longhorn quarry

Preliminary Overall Area Development Plan

Re: Longhorn

POADP # 429 -B

Preliminary Overall Area Development Plan

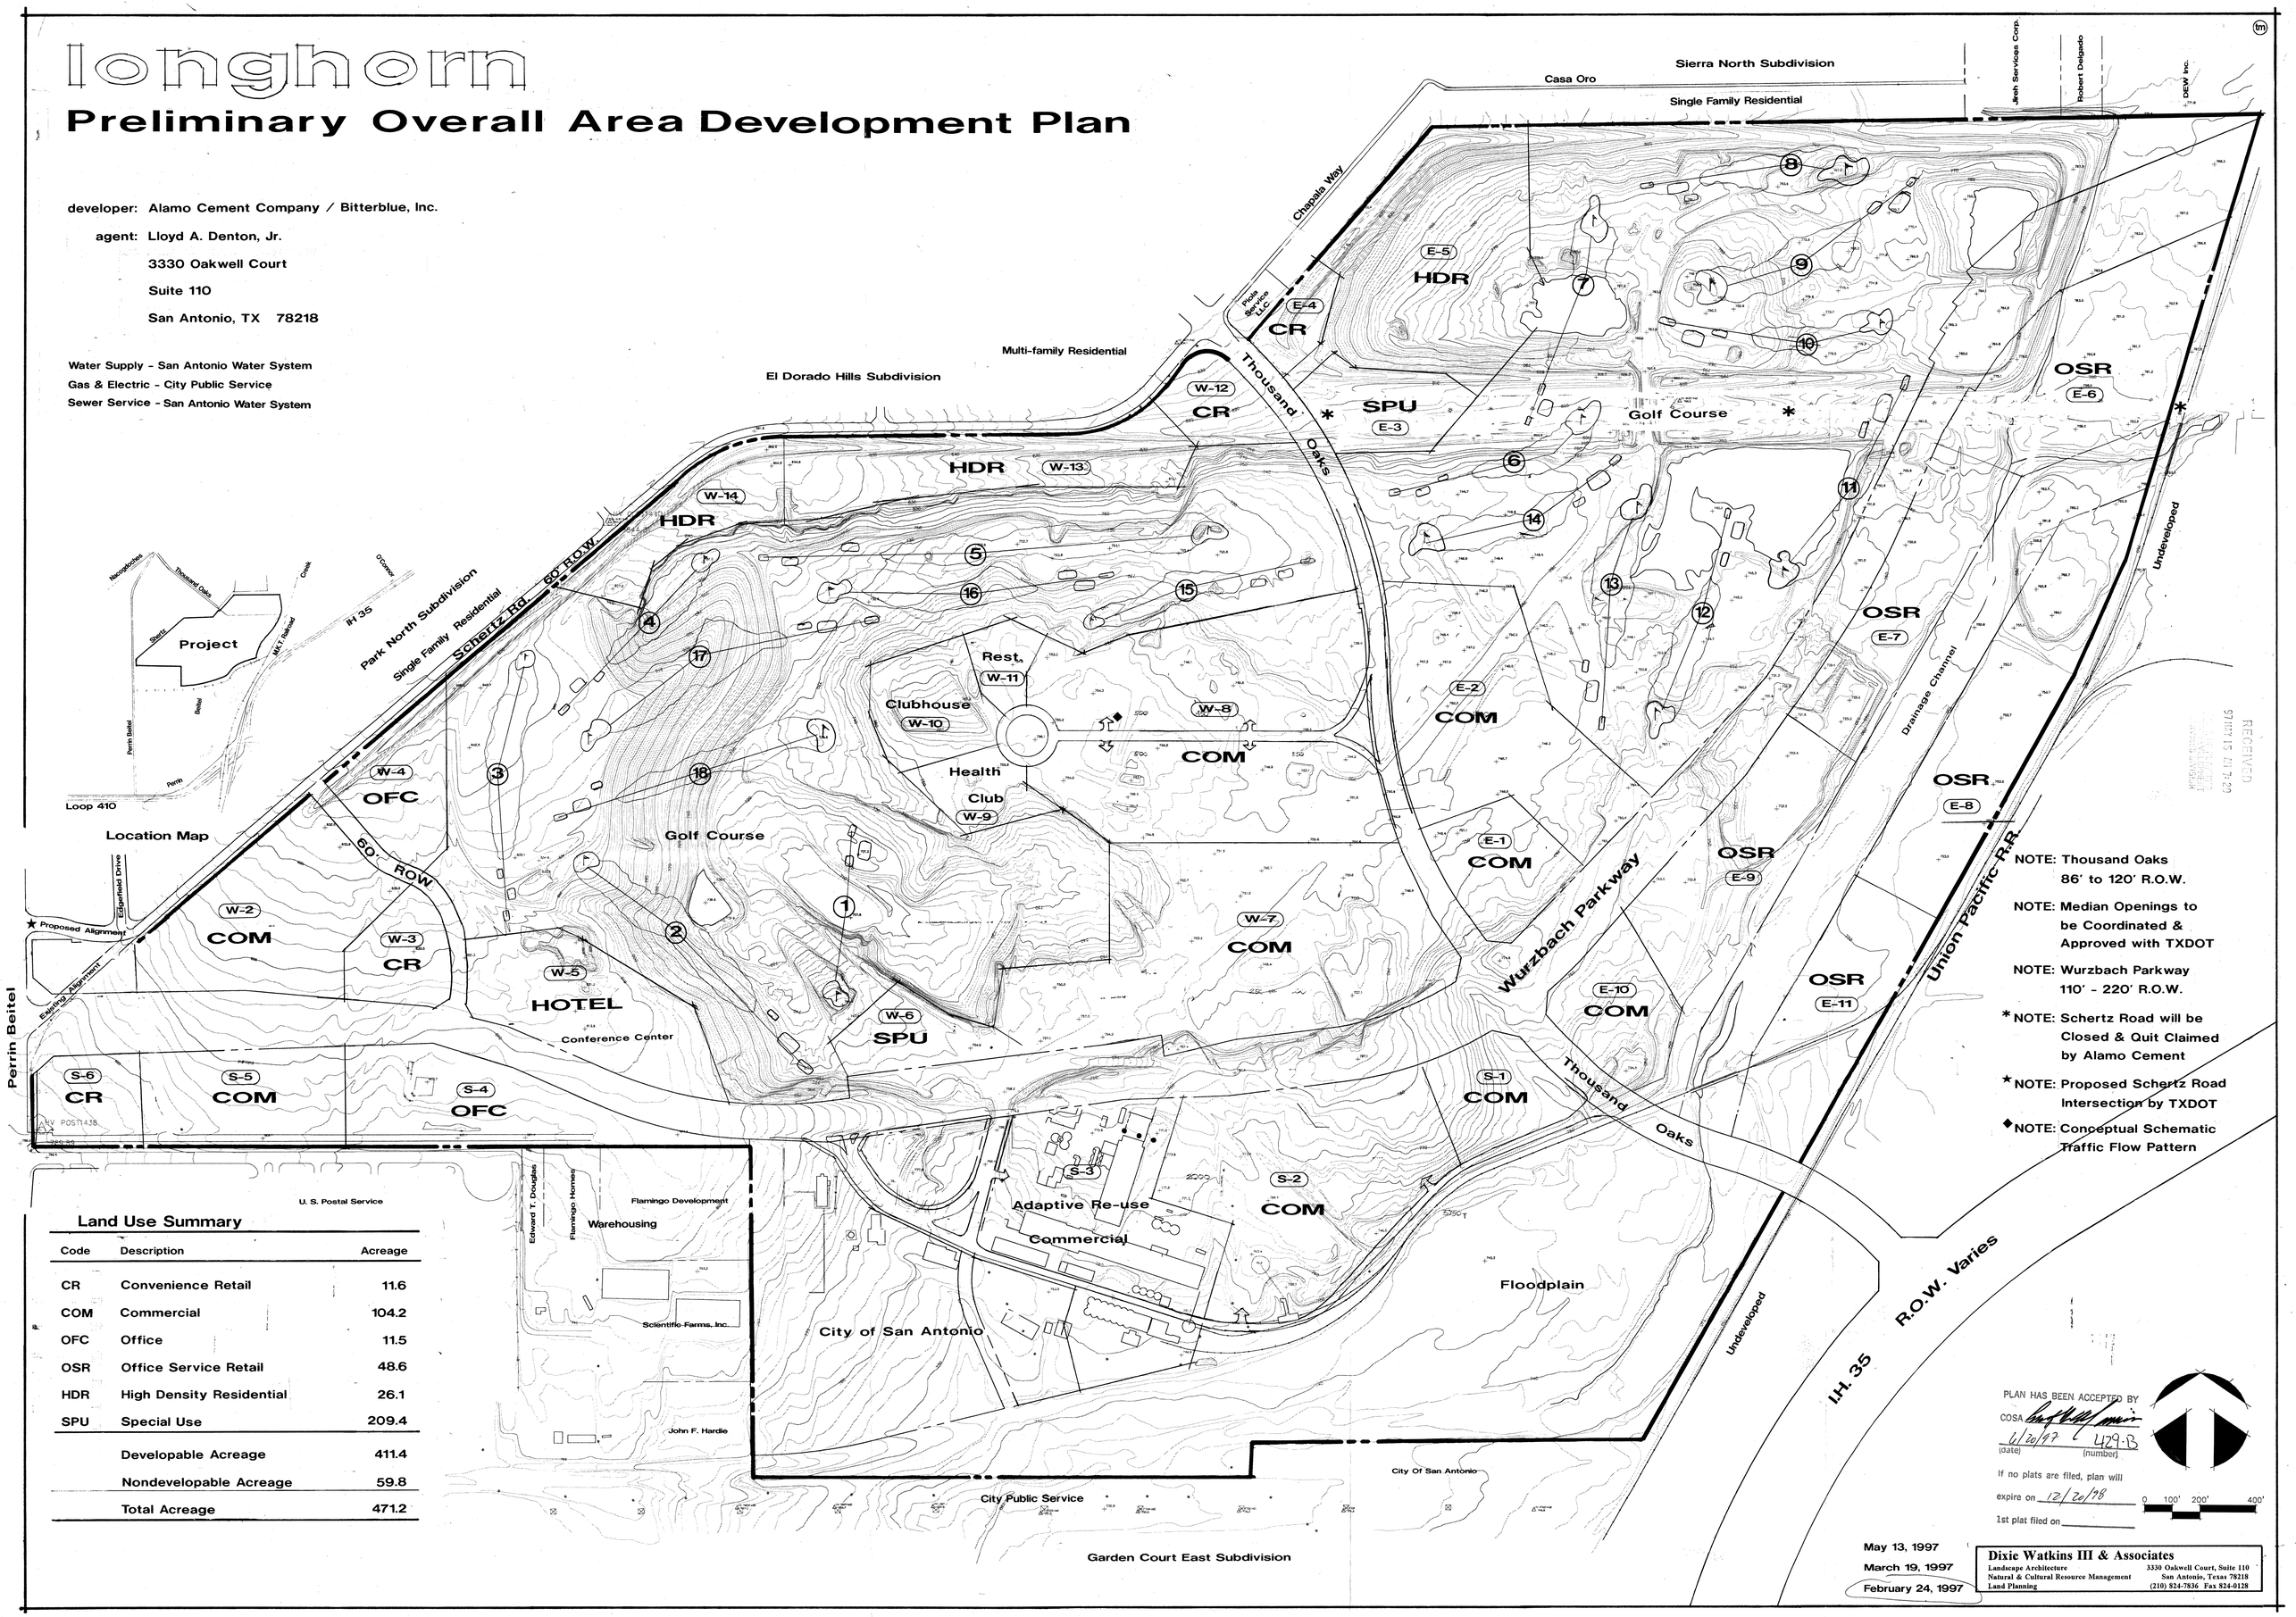
- Based on the topography, a Flood Plain Study and drainage review will probably be required during the platting process.
- If the proposed development is not platted in phases or units this POADP will not be valid.
- Access and R.O.W. issues along State facilities need to be resolved with TXDOT. For additional information about these requirements you can contact TXDOT at 615-5814.
- Perrin Beitel is a Secondary Type A Major Thoroughfare, and requires 86' of ROW. In addition, according to the Unified Development Code all Collector streets must have at least 60' of ROW.
- The arrows provided in conjunction with the transportation network are access point for driveways.

P.O.A.D.P. Reviewed for:	Comments
Noise Mitigation	For residential development directly adjacent to State ROW, the developer shall be responsible for adequate set-back and/or sound abatement.
R.O.W. Requirements	None
Access Limits/Restrictions	Access to the Parkway is limited and access controlled by deed. **See additional comments below for restrictions**. All access locations and permitting will be as directed by "Regulations For Access Driveways to State Highways".
WPAP Requirements	None

ADDITIONAL COMMENTS: The Wurzbach Parkway is a controlled access facility. **No median openings will be permitted.** Access is denied to the following properties (identification labels as identified on the POADP) W-3, W-6. Access is limited to the following properties W-5, S-4, W-7, S-3, E-9, E-7, E-6. Future street intersections shown on the POADP do not correspond with those approved on the Wurzbach Parkway schematic and Right of Way maps. The proposed right of way width of the Parkway, shown from Thousand Oaks to the Union Pacific Railroad, is not representative of the actual identified right of way. Inconsistencies in right of way depiction could have impacts upon planned usage. Complete copies of the approved Wurzbach Parkway schematic and right of way maps may be obtained from the Texas Department of Transportation.

Comments: ~~TIA~~ Submit a TIA
2. Show Row of Renin Bietal.

Comments: FLOOD PLAIN REQUIREMENTS AND DRAINAGE EASEMENT WILL BE REQUIRED. AND ADDRESS DURING THE PLATTING PROCESS

Comments: FLOOD PLAIN REQUIREMENTS AND DRAINAGE EASEMENTS WILL BE REQUIRE AND ADDRESS DURING THE PLATTING PROCESS.

resubmit Wurzbach R.O.W.
Thousand Oak

(*) note parkway 110 to 220 confor

median opening must be coordinated and approved by TXDOT

Call TXDot about Wurzback alignment

* What abot roadway from Thousand Oaks thru golf Couse (What are you doing w/it

* ID all Street clefficetion ie. arrows (driveways or street

* abuting land owners

* Show connection w/ nearby streets such as I.35

* Show new alignment by others' forschertz Road

* What type of ~~street ie are the 60'ft collector~~ provide 60'ft I.D. all streets

What are arrows

NOTE: Thousand Oaks 86' to 120' R.O.W.

NOTE: Median Openings to be Coordinated & Approved with TXDOT

NOTE: Wurzbach Parkway 110' - 220' R.O.W.

* NOTE: Schertz Road will be Closed & Quit Claimed by Alamo Cement

★ NOTE: Proposed Schertz Road Intersection by TXDOT
